PRIORITY DEVELOPMENT PROJECT STORM WATER QUALITY MANAGEMENT PLAN FOR VISTA II

Revision Page

February 14, 2024

This PDPSWQMP presents a revision to the October 16, 2023 report pursuant to the County of San Diego plan check comments received January 24, 2024. The following text identifies the plan check comments along with the responses in bold.

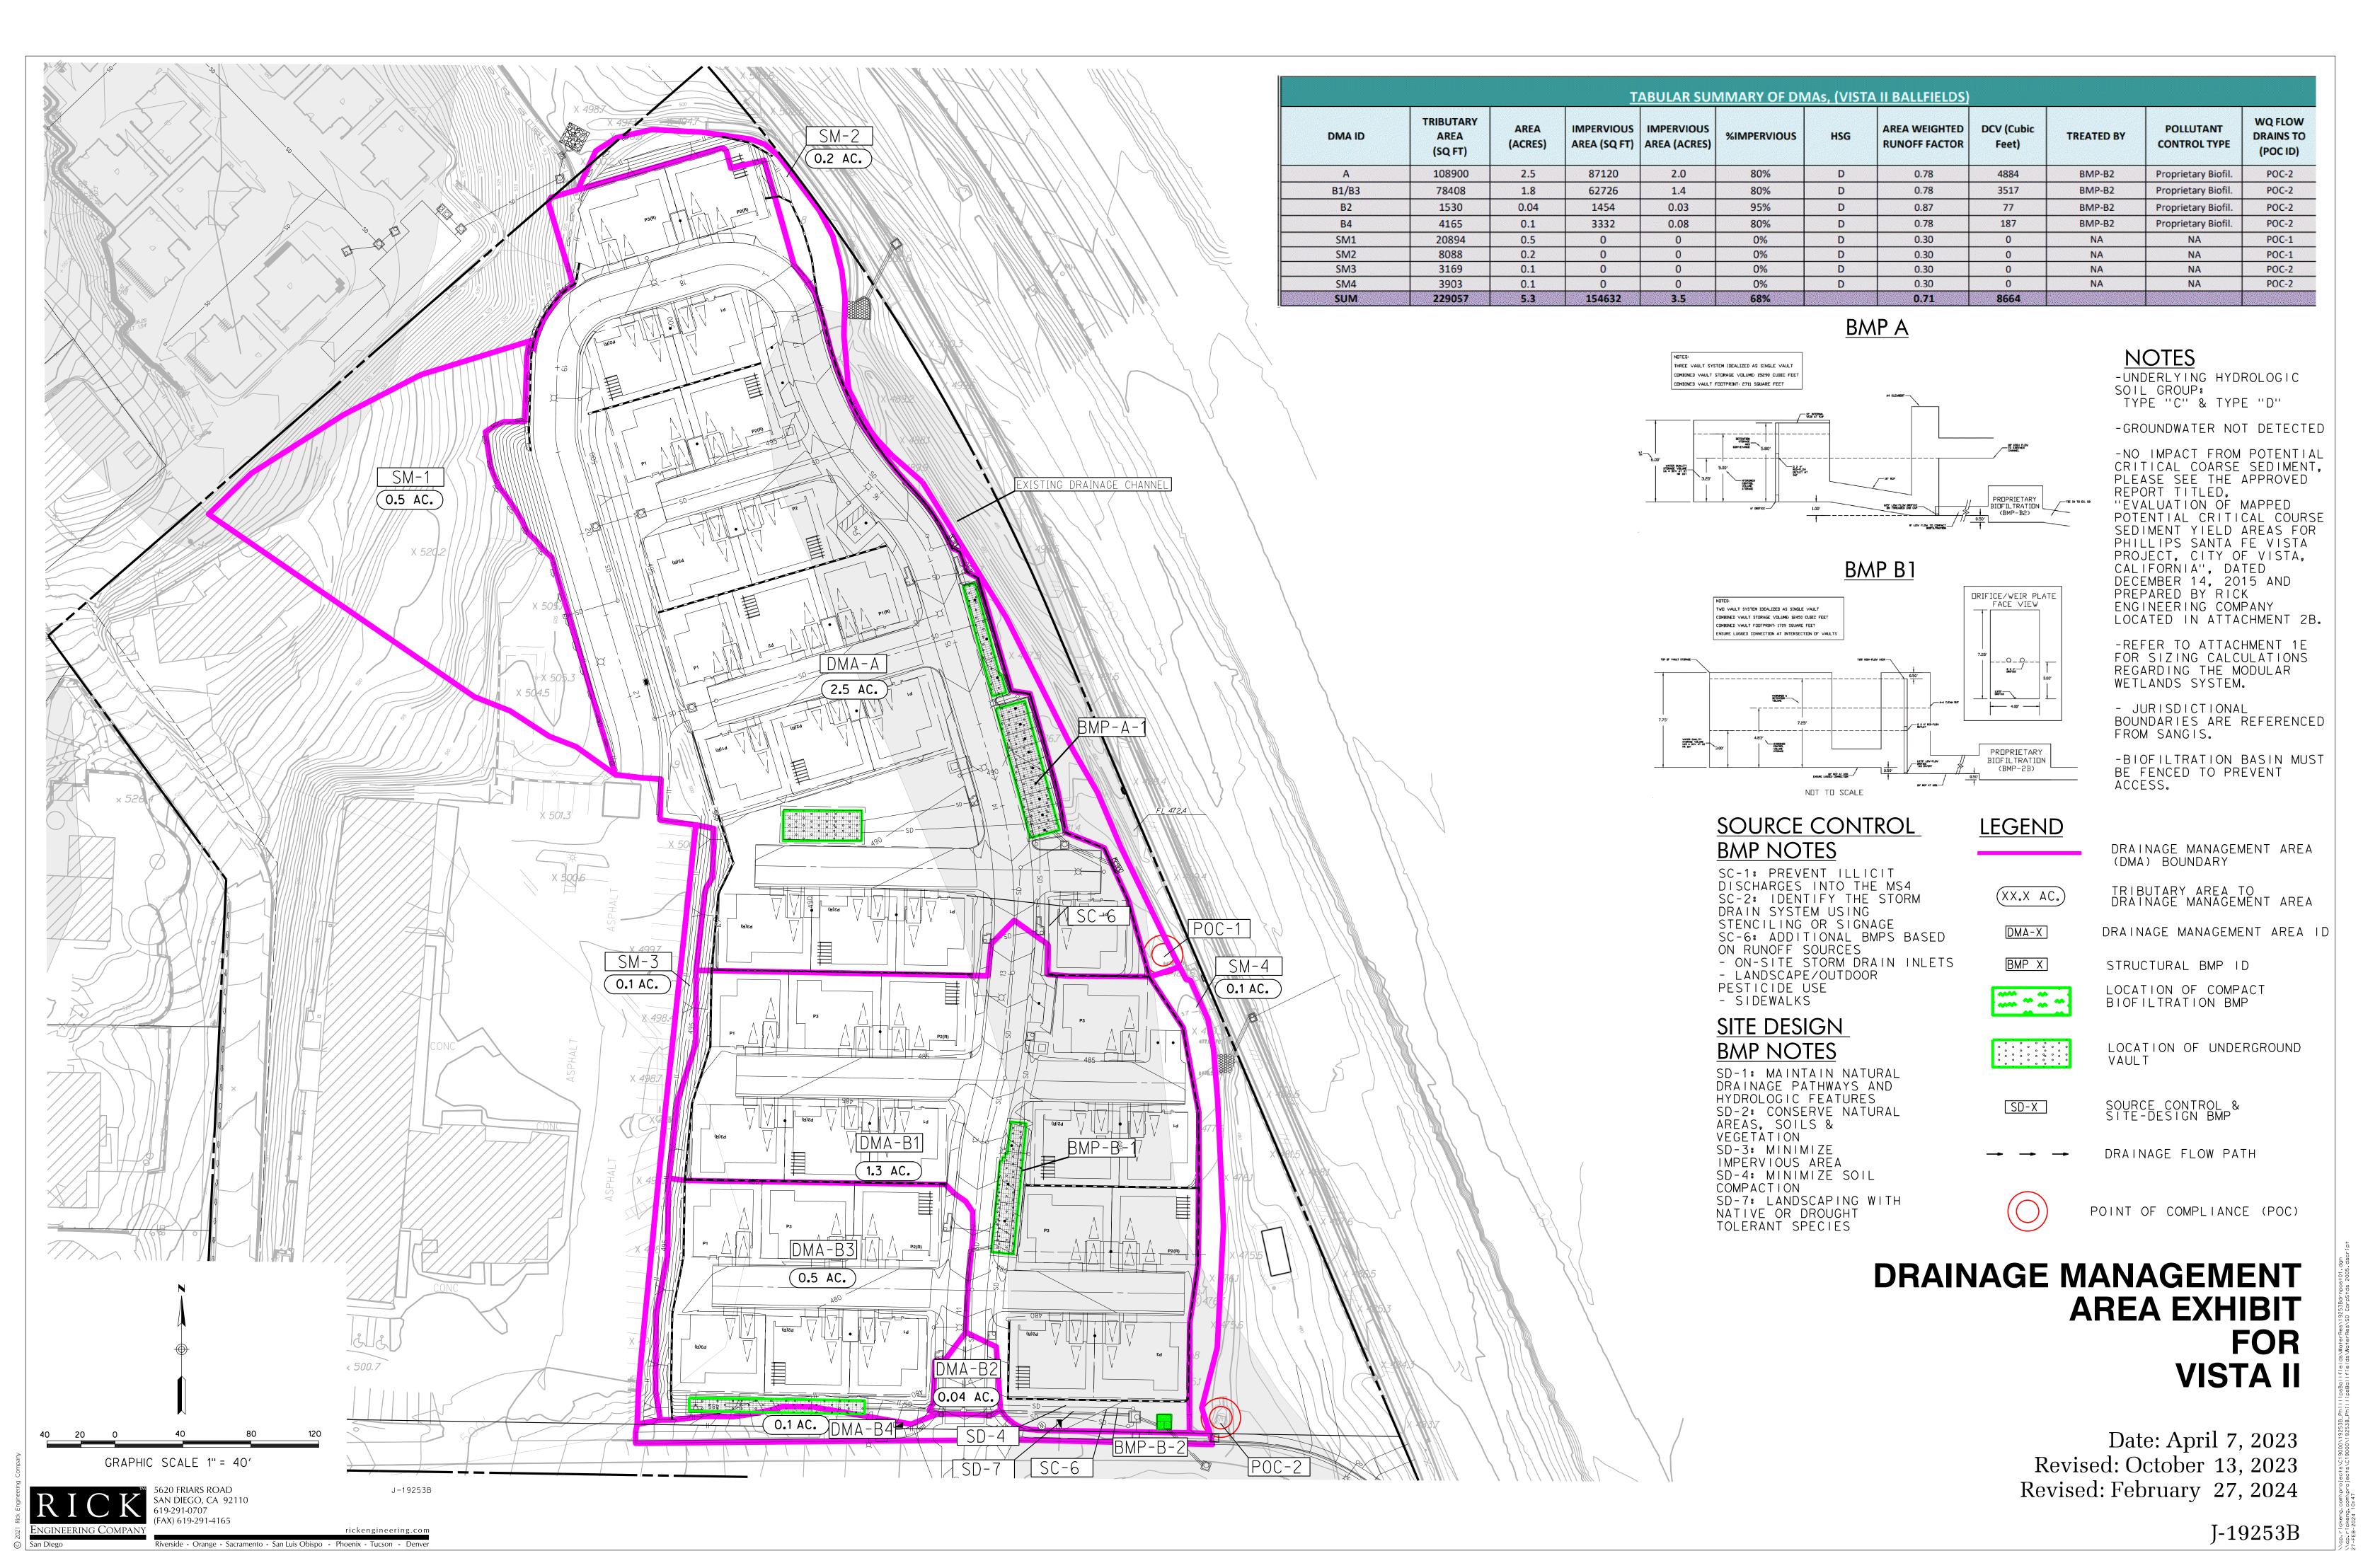
6-8. Attachment 2.1 DMA Exhibit:

3rd Comment Review: Per Section 1.7 of the County BMP Design Manual, all impervious surfaces in the existing condition should be reviewed if they are a part of the project, because of the portion of the proposed improvements are located in Parcel 1 then the existing impervious surfaces of Parcel 1 must be included as part of the 50% rule. If a proposed parcel from this subdivision does not include any proposed improvement, then it be labeled as "existing and no plans for development." The resultant proposed parcels with improvements would be labeled as "new development." Please provide the project description and how it defines Parcel 1.

6-13a. Correct the portion of the DMA Exhibit showing the connections for BMP-A2 to be consistent with profile detail provided.

- 6-9 Attachment 2.1 DMA Exhibit: The DMA exhibit is incomplete. Include the following information:
 - -Provide the underlying hydrologic soil group.
 - -Provide the approximate depth to groundwater.
 - -Clearly demarcate and provide an annotation for natural hydrologic features, including the existing channel along the east side of the proposed development.

6-10 Attachment 2.1 DMA Exhibit: Clarify DMA-B. The current limits appear to only include a portion of the BMP directly adjacent to the Hanalei Drive right of way and there appears to be a smaller DMA where the proposed private road connects to Hanalei Drive.

6-11 Attachment 2.1 DMA Exhibit: Provide a table indicating the area in square feet of impervious surfaces versus the area of pervious surfaces in each DMA.

6-12 Attachment 2.1 DMA Exhibit: Include detail views for all of the proposed BMPs, including how the proposed vaults are interconnected to share the volume of stormwater before going to the modular wetland and biofiltration basin.

6-13 Attachment 2.1 DMA Exhibit: Clarify how treated stormwater from BMP-A2 reaches the proposed POC on Hannalei Drive. According to the CEQA-Level Drainage Report Section 1, a storm drain is proposed along the existing channel (but does not appear to be shown) but Section 3 of the report states it will discharge to the channel. If BMP-A2 will discharge into the existing channel, a second POC is needed.

6-14 Attachment 2.1 DMA Exhibit: Clarify what the red circled area indicates. If it was intended to show the proposed POC, it appears to have been misplaced.

Response: All work will take place in Parcel 2. An updated 50% rule exhibit has been added to Attachment 2.1 to show updated lot lines and extent of work. Lots 1 and 3 have been labeled as "existing and no plans for development".

DMA exhibit has been updated to show consistency with detail.

Comment noted. These requests have been incorporated into the latest DMA exhibit.

The portion of private road that connects to Hannalei drive (DMA-B2) drains directly to BMP-B2 to receive water quality treatment. BMP-B-1 will provide adequate storage to meet HMP requirements for both DMA-B1 and DMA-B2.

Comment noted. DMA summary table have been included after the DMA exhibit.

An outlet to the existing channel is now being shown on the DMA exhibit in Attachment 2.1. A second POC has been added to account for discharge flowing into the channel from DMA A.

DRAINAGE STUDY MAP FOR VISTA II BALLFIELDS PRE-PROJECT

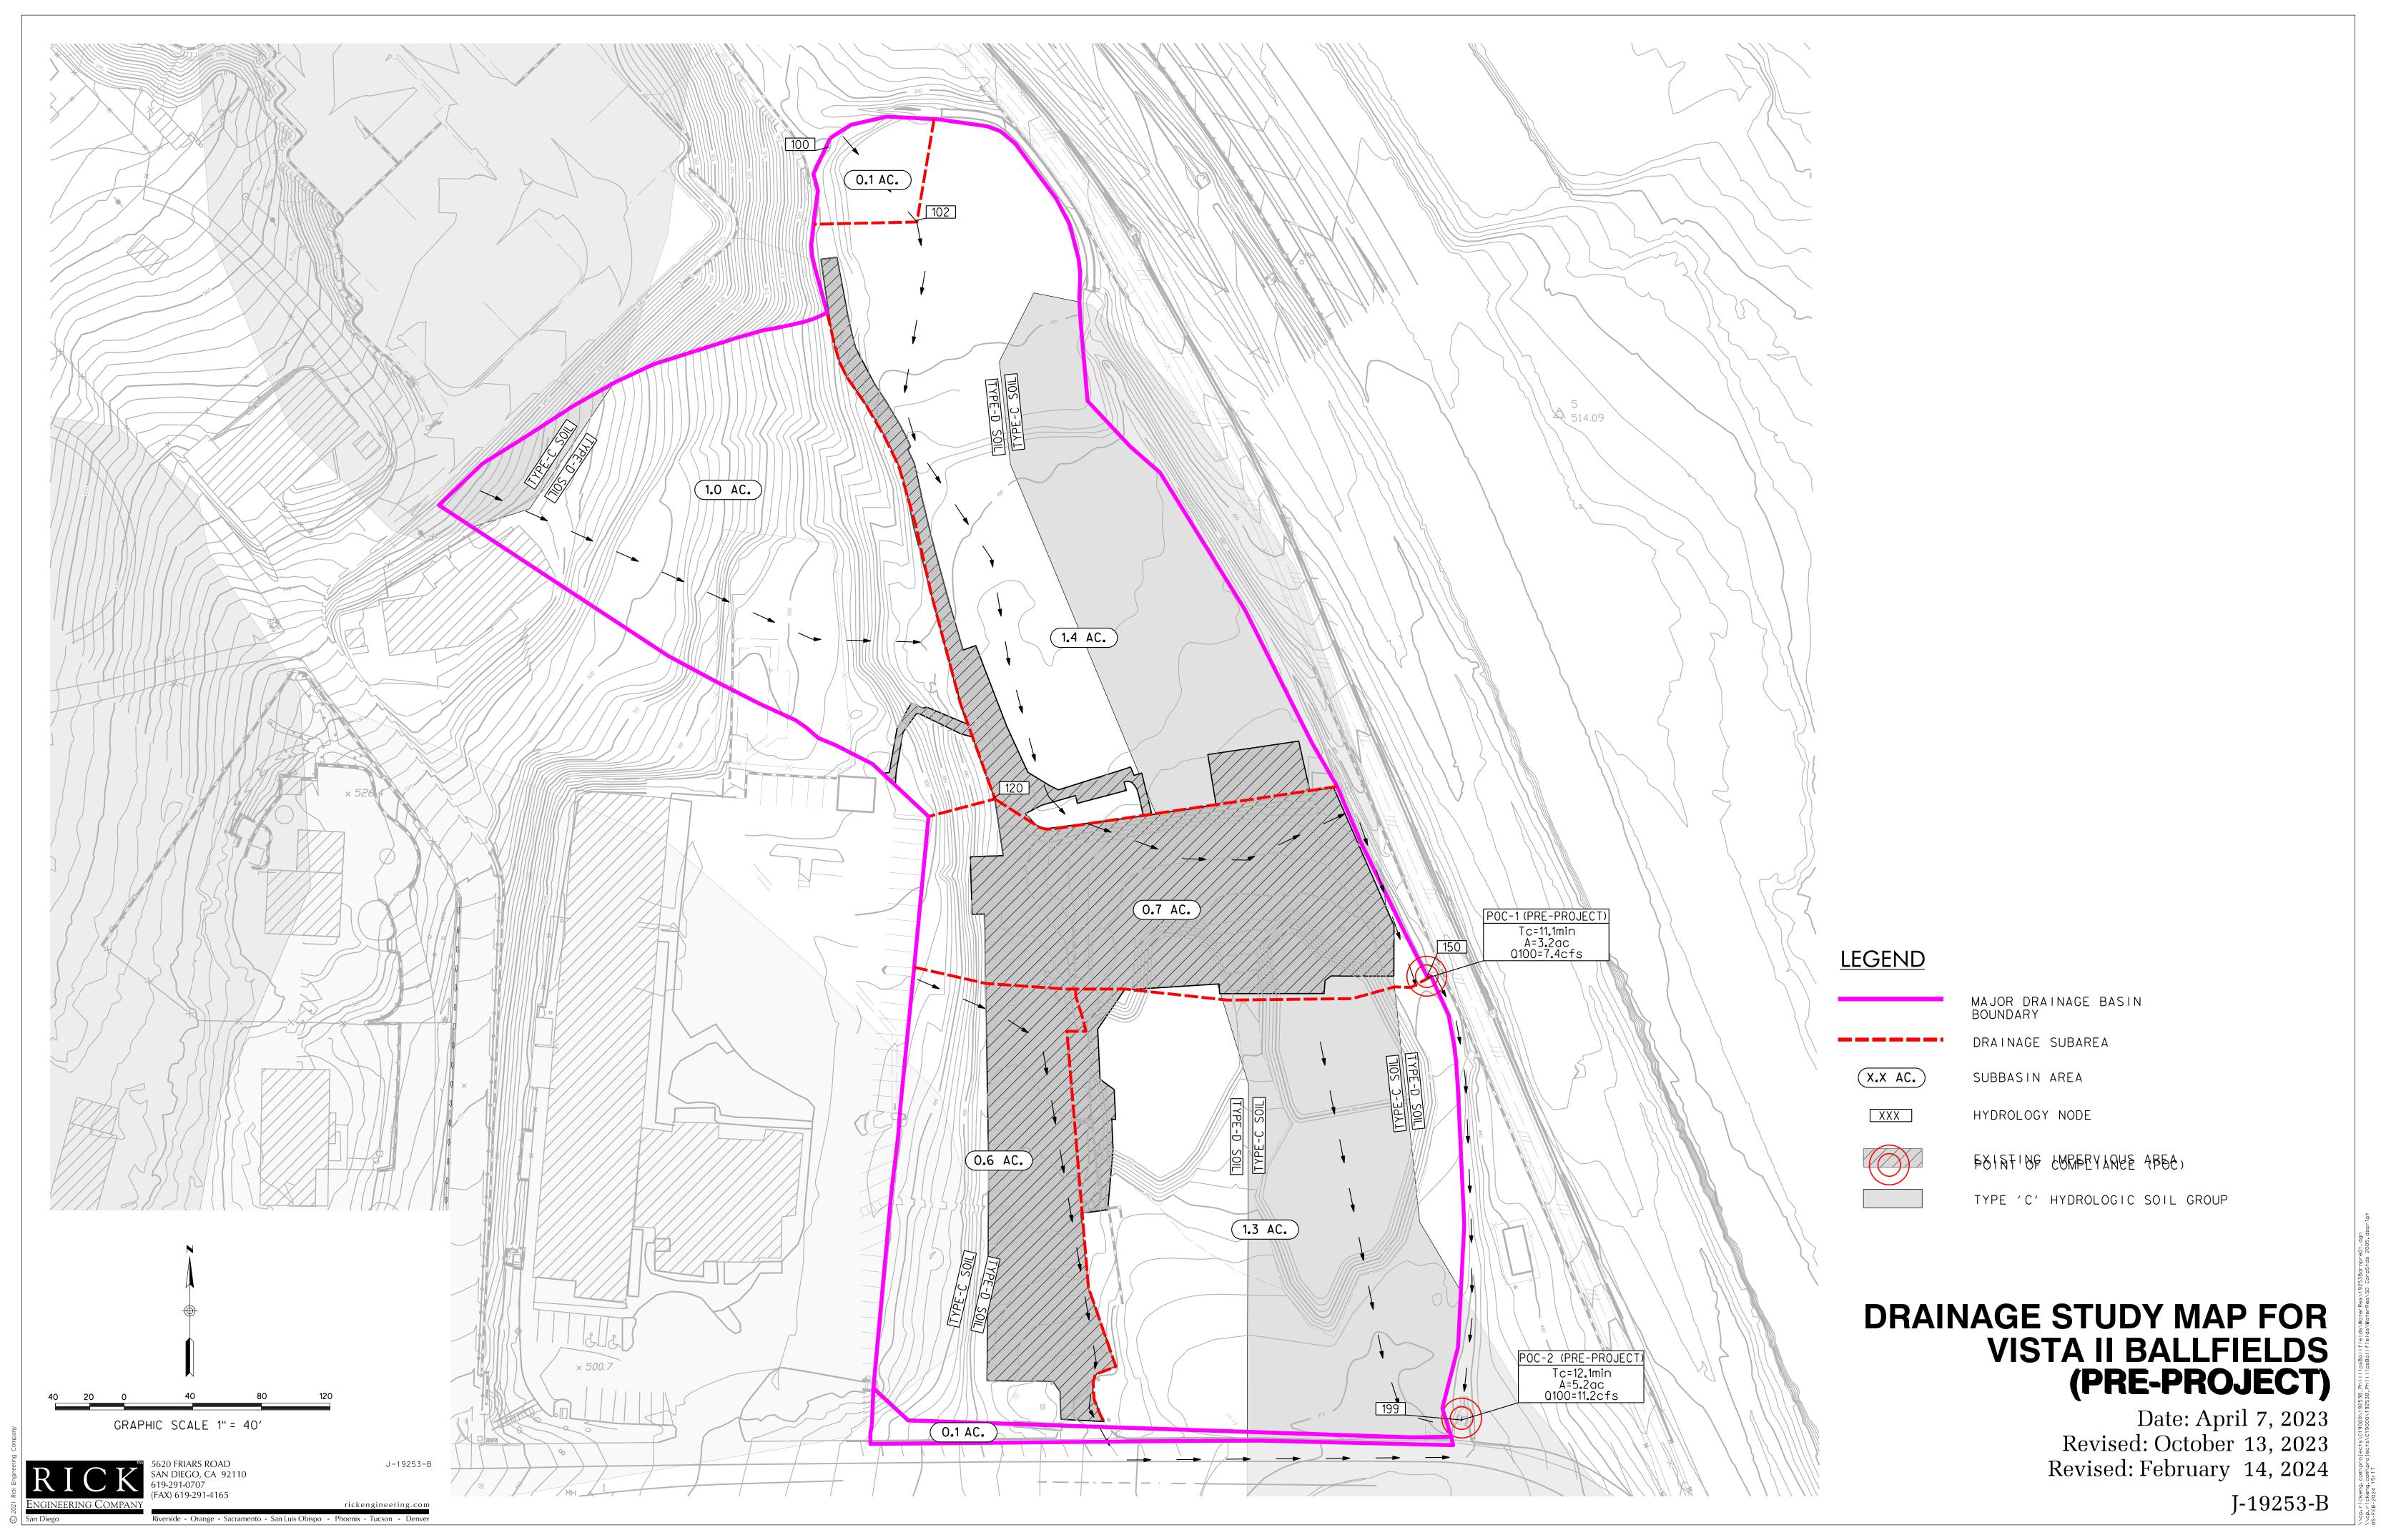
The pre-project Hydromodification exhibit appears to indicate the underlying soil hydrological groups incorrectly toward the eastern side of the project. Correct to be consistent with the Soil Hydrologic groups from the NRCS data.

3rd Review Comment: From NRCS data, SbA soil is C soil & BID2 is a D soil. Please correct.

6-25a. SWMM Model The pre-project Hydromodification exhibit appears to indicate the underlying soil hydrological groups incorrectly toward the eastern side of the project. Correct to be consistent with the Soil Hydrologic groups from the NRCS data.

Response: Soil group labels have been updated in the pre-project hydromodification exhibit.

The labels on the Pre-Project Hydromodification exhibit have been updated to be consistent with the NRCS soil data.
